Subject: 04-003/17 SQUEAKING/GRINDING NOISE FROM REAR BRAKE	Bulletin No.: 04-003/17
	Last Issued: 06/14/2017

2014-2016 Mazda3 (Japan built) vehicles with VINs lower than JM1*****355941 (produced before June 24, 2016)

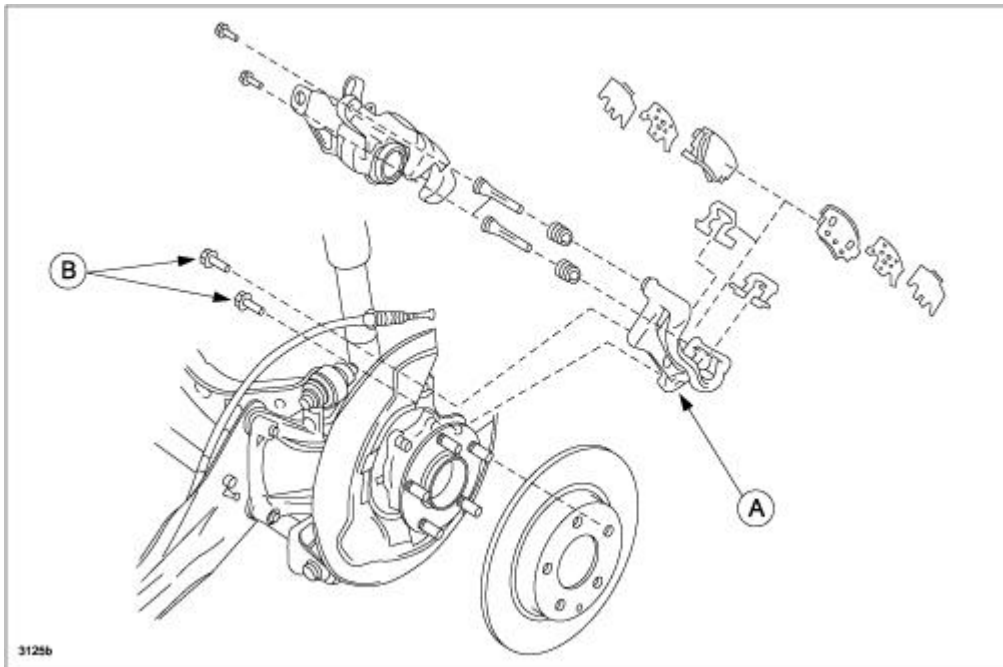
Some vehicles may experience a squeaking/grinding noise from the rear brake even after the brake pedal is released. Upon inspection, the caliper mounting support is corroded and one of the disc pad is abnormally worn out (A). This is caused by vehicle usage in an area using road salt. The surface of the mounting support may swell from corrosion causing premature disc pad wear and brake noise.

To correct the problem, an improved caliper mounting support has been newly established as a service part. The anti-corrosion surface treatment has been changed from Zn to Zn-Ni plating.
